PURCHASING SECTION
13450 – 104 Avenue, Surrey BC V3T 1V8
Tel: 604-590-7274
E-mail: purchasing@surrey.ca
ADDENDUM #1

REQUEST FOR QUOTATIONS (RFQ) NO.:	1220-040-2017-023
TITLE:	SKYLIGHT REPLACEMENT AT FLEETWOOD LIBRARY
ADDENDUM ISSUE DATE:	January 26, 2017
CLOSING DATE:	prefer to receive Quotations on or before: January 31, 2017

**SK1 (REV. 1)
SKYLIGHT PLAN & ELEVATION
DATED JAN 18/17**

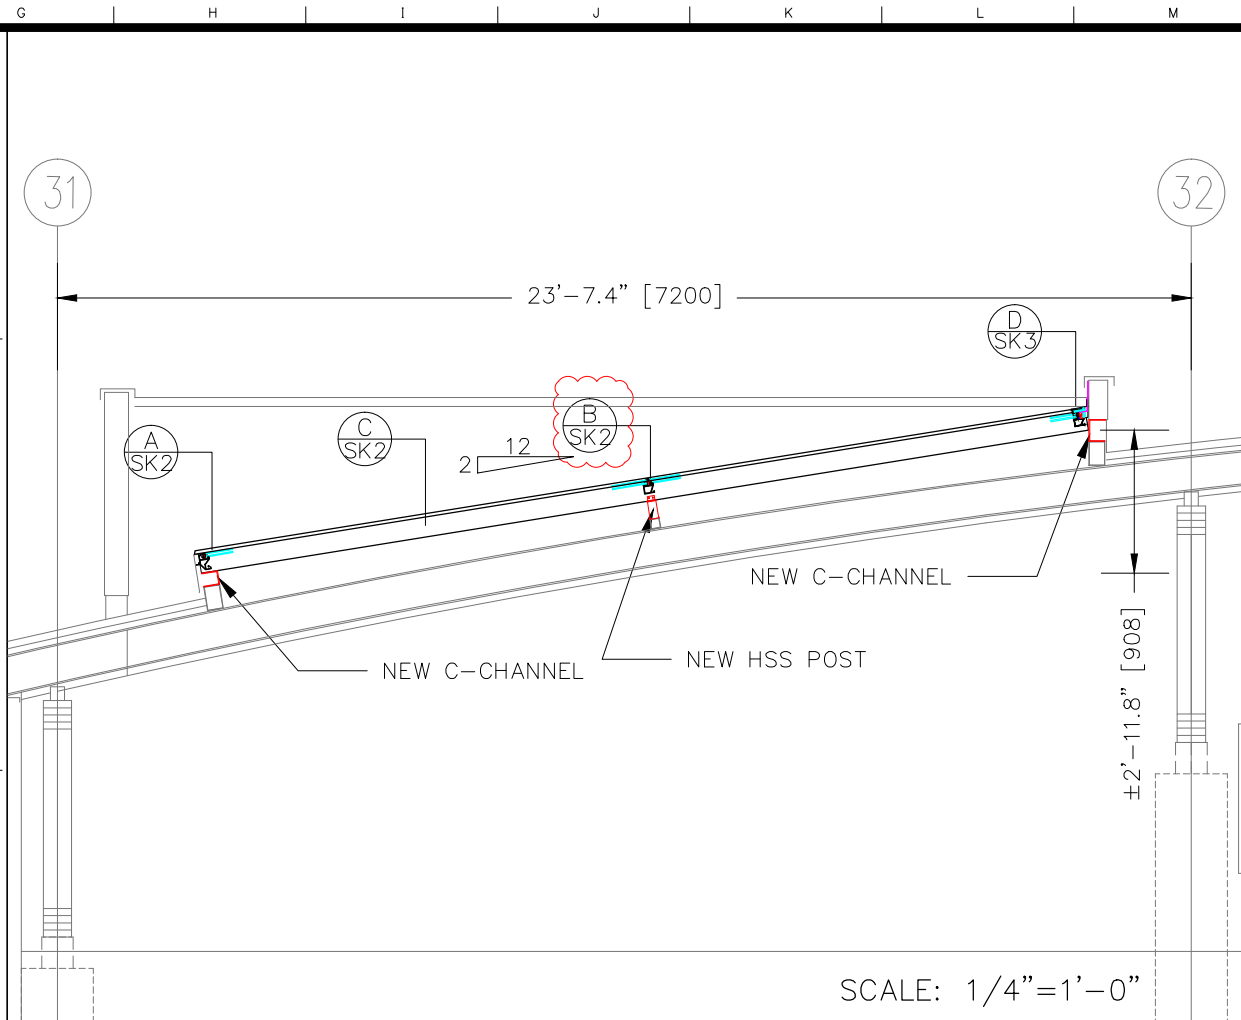
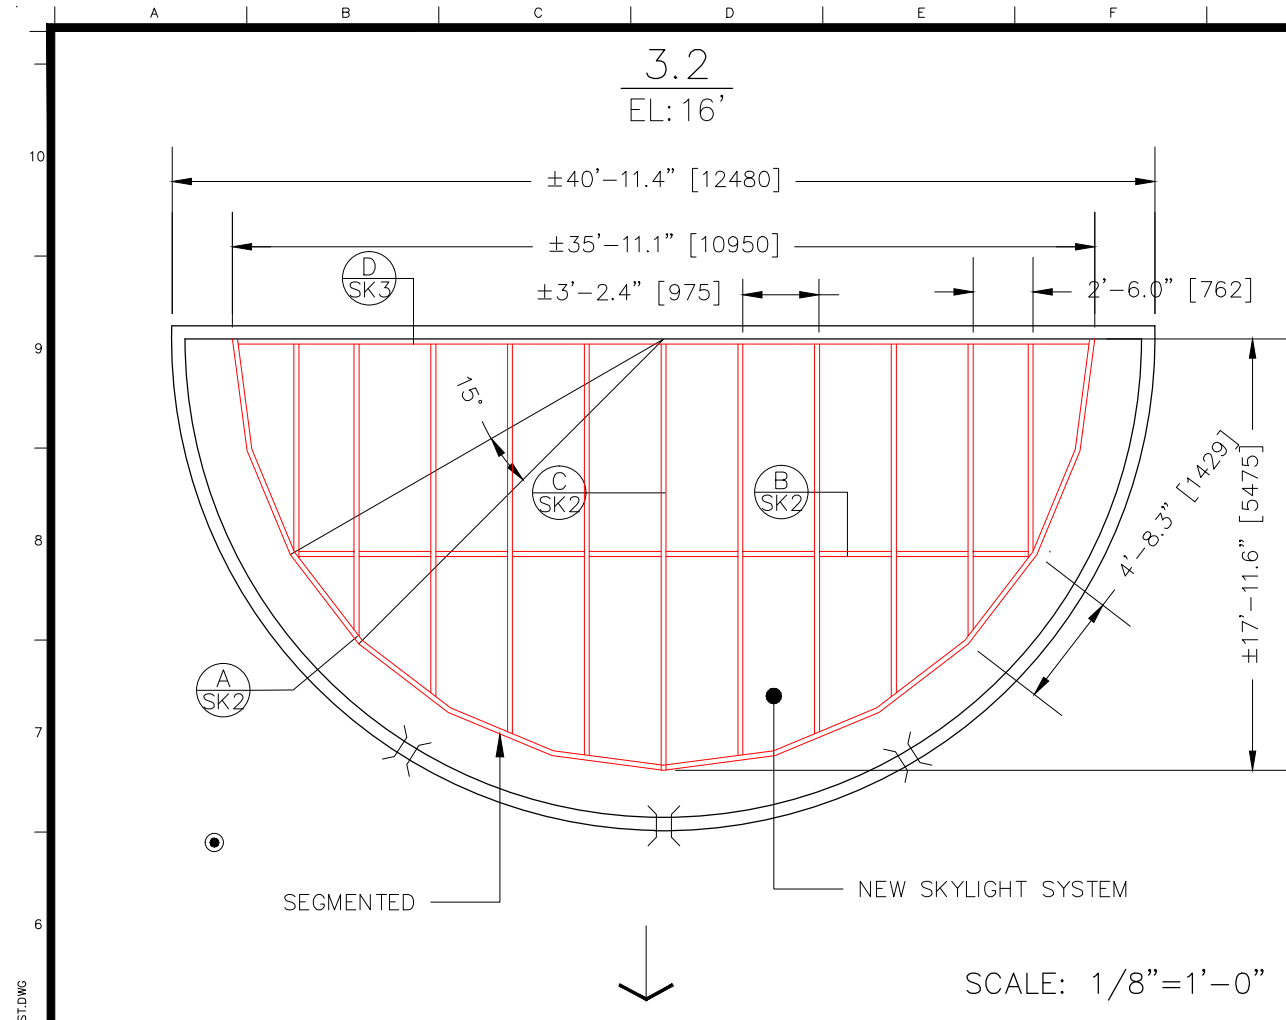
The continuous I Beam (S8x18.4) previously detailed to support the new skylights is removed from the design and HSS 3X3X1/4 Posts are introduced to support each skylight rafter. The drawing sheet SK-1, details B/SK-2 and E/SK-3 are revised to reflect the design change:

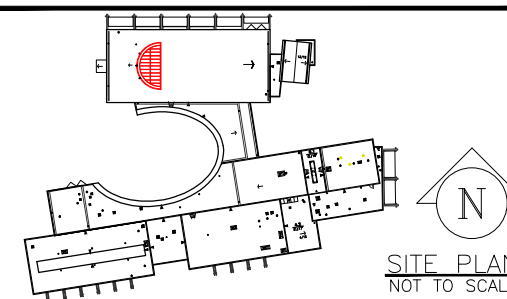
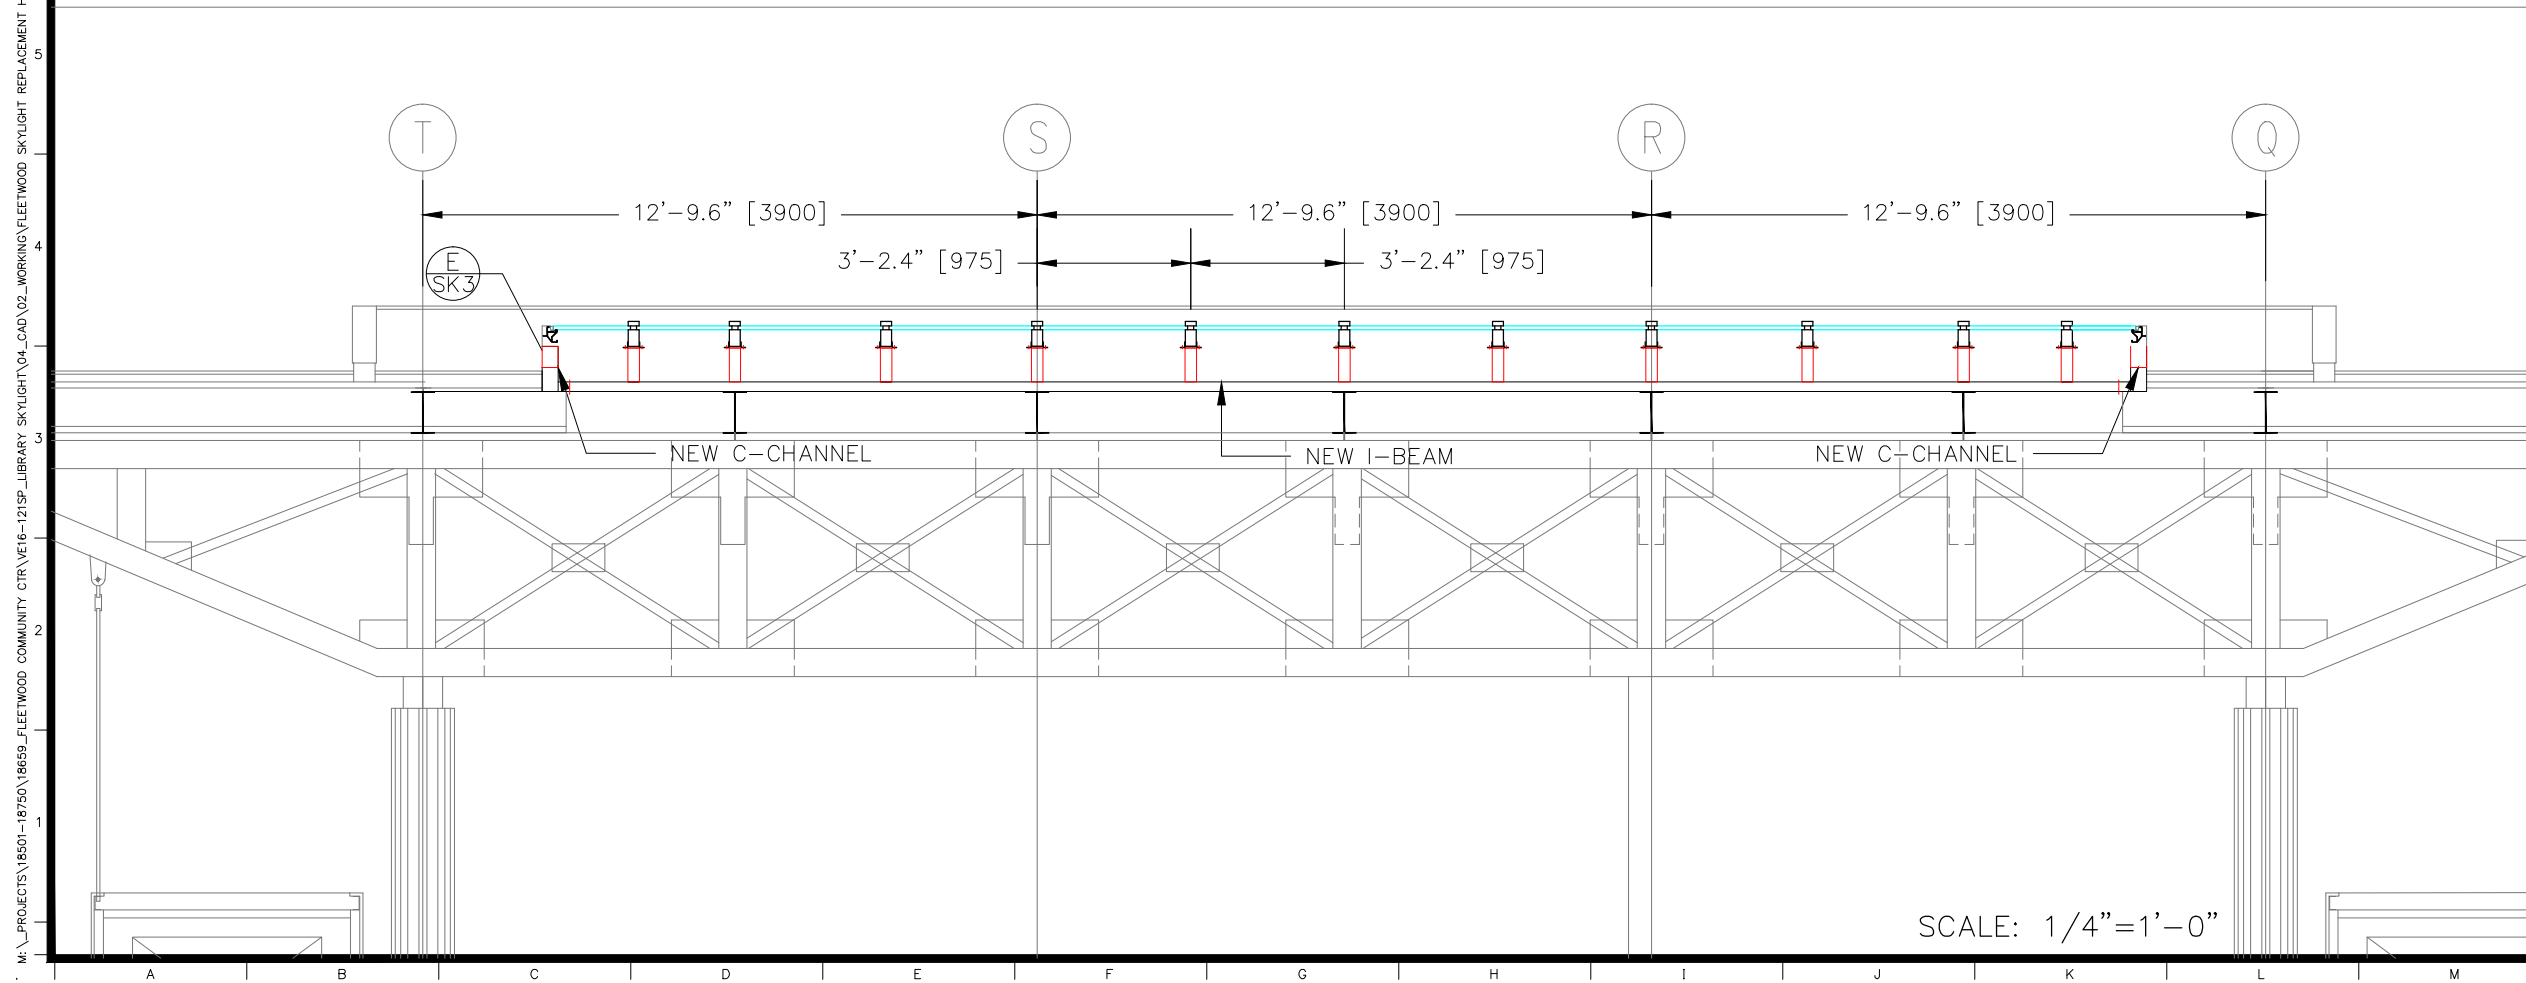
Skylight Plan & Elevation drawing SK1 dated Jan 10/17 is hereby deleted and replaced by SK1 (REV. 1), Skylight Plan & Elevation dated Jan 18/17. Refer to Attachment #1 of this Addendum No. 1 for the revised SK1, Skylight Plan & Elevation drawing.

**SK2 (REV. 1)
SKYLIGHT DETAIL
DATED JAN 18/17**

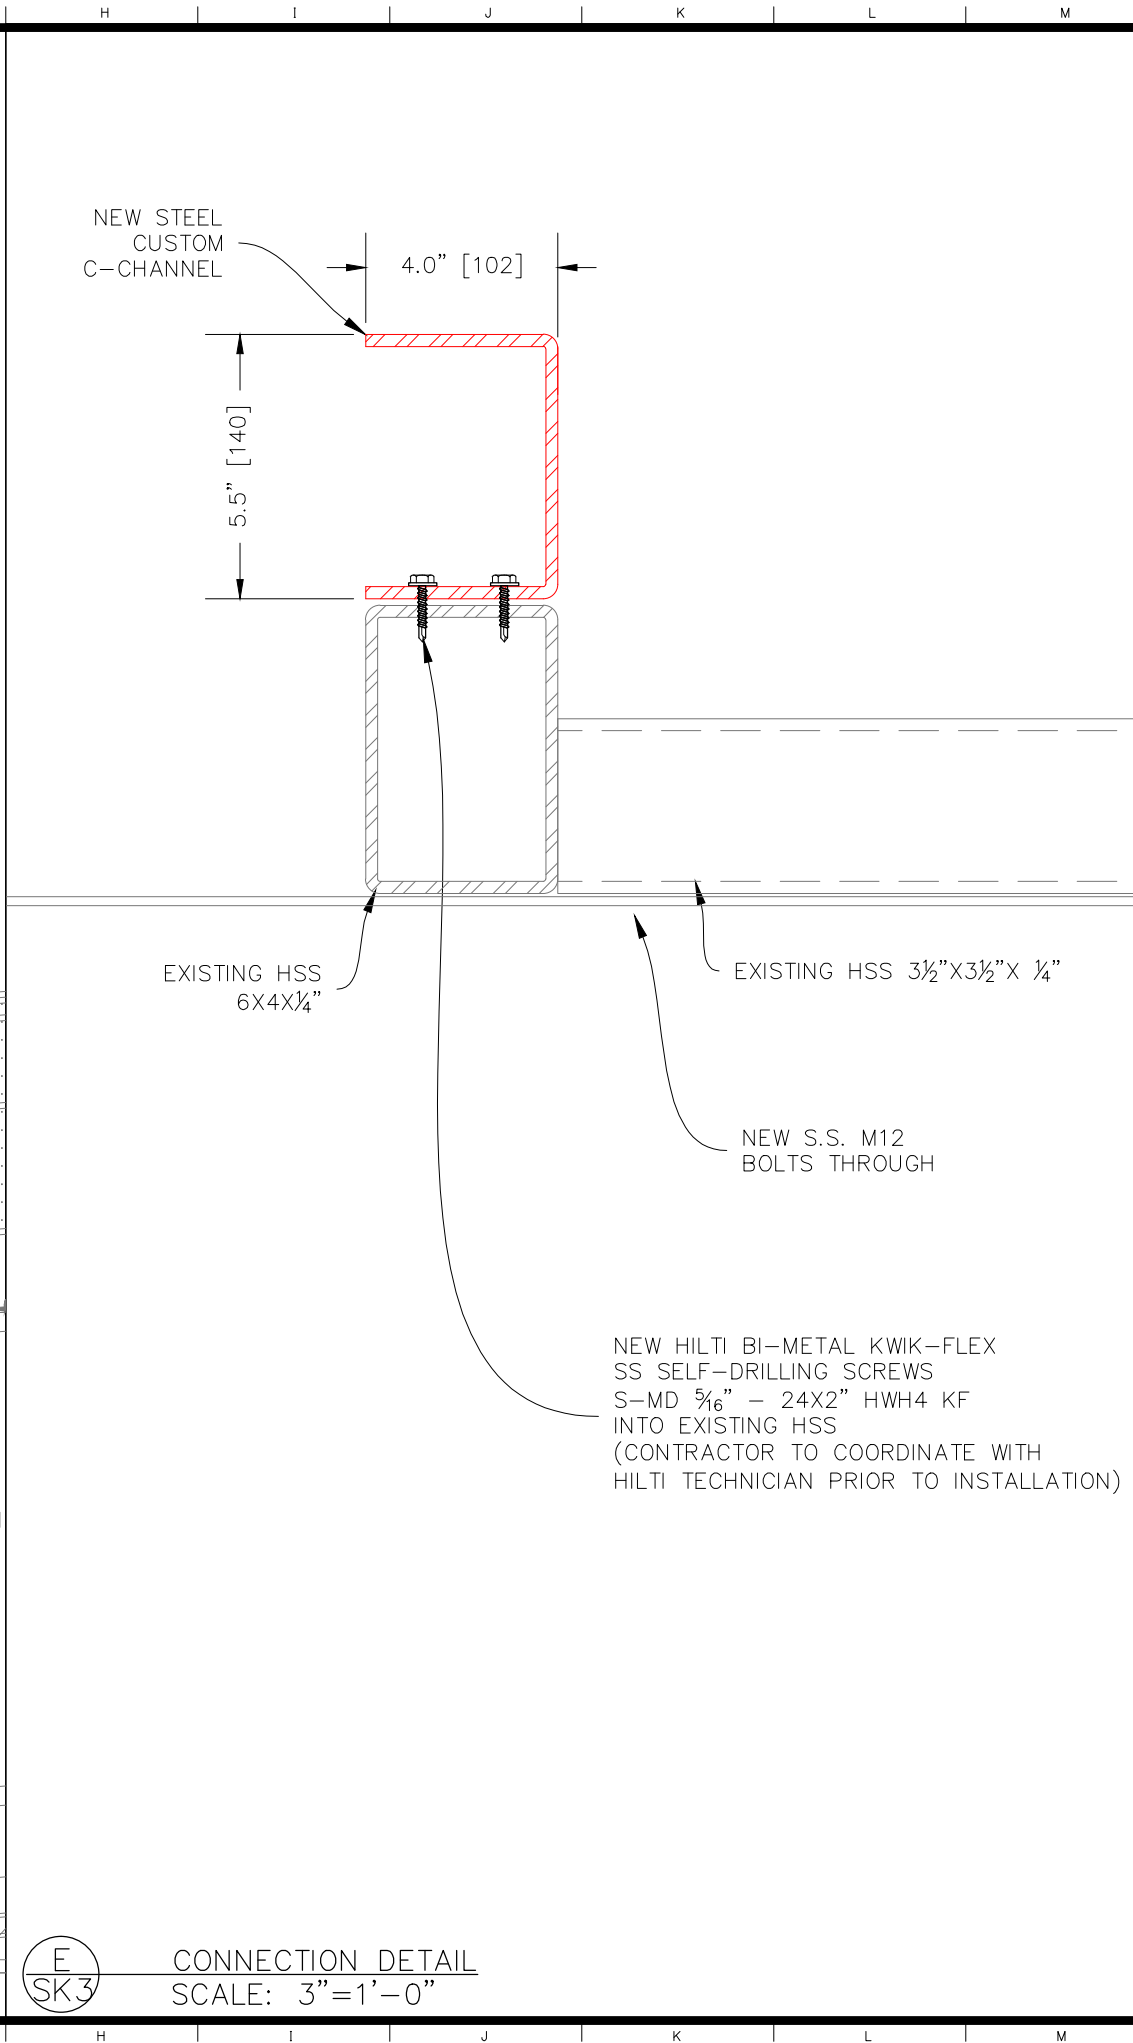
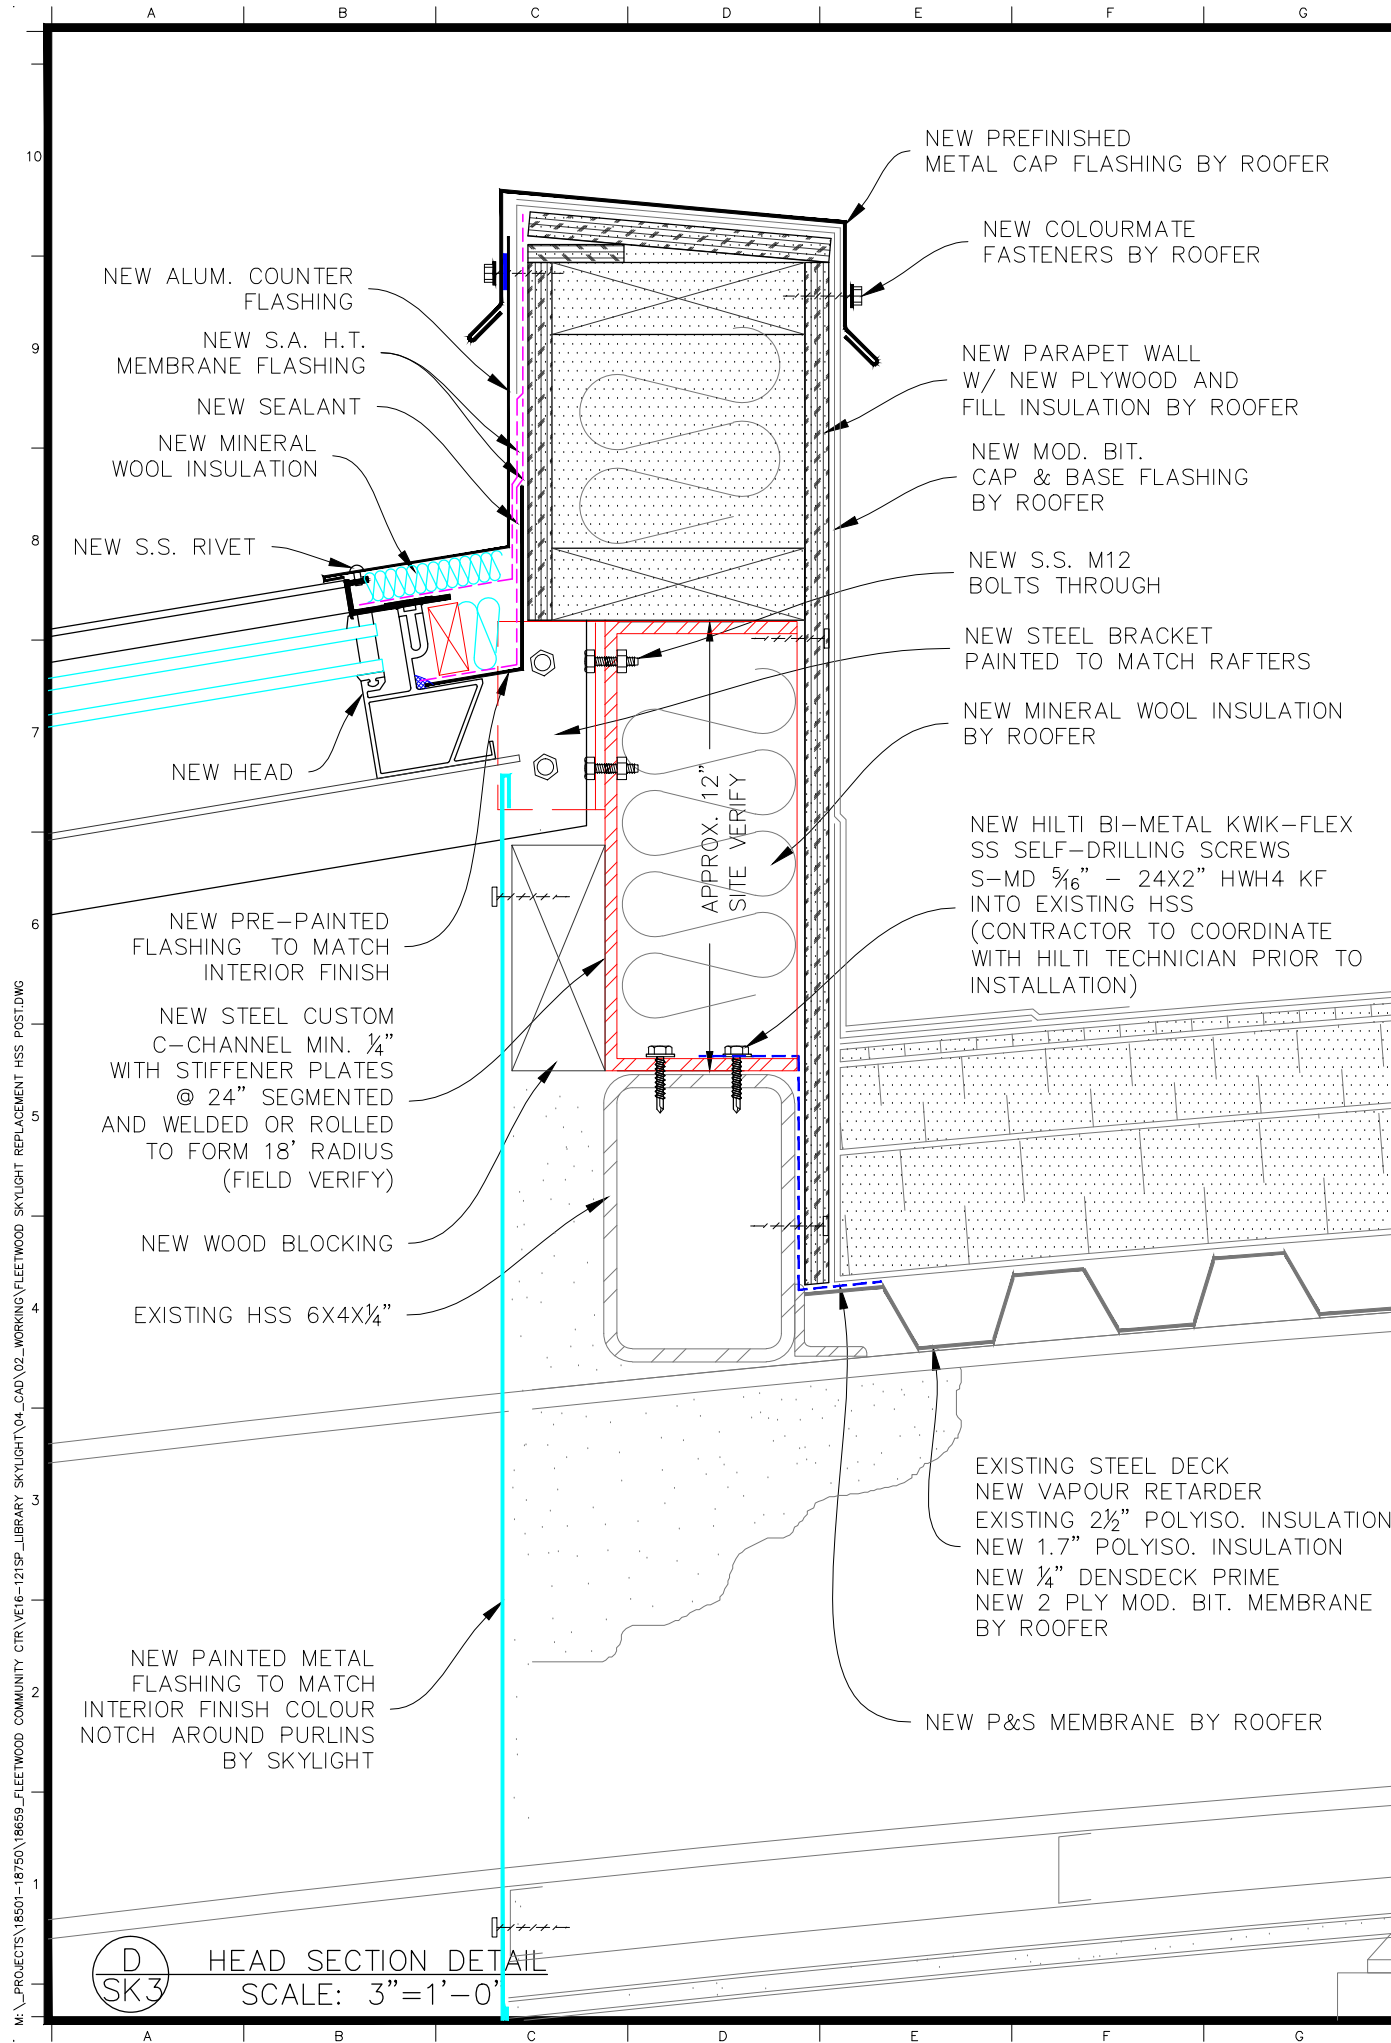
Skylight Detail drawing SK2 dated Jan 10/17 is hereby deleted and replaced by SK2 (REV. 1), Skylight Detail dated Jan 18/17. Refer to Attachment #2 of this Addendum No. 1 for the revised SK2, Skylight Detail drawing.

Q5: Regarding Detail A, SK2, please confirm: Aluminum foil face membrane is in our scope, as well as the polyiso insulation and the flashings on the exterior. Wood blocking and the interior flashing is by others.

A5: Review drawings, cross referencing to the specified roofing details would be useful for the bidders. Wood blocking will be roofing, interior flashings by the skylight bidder.
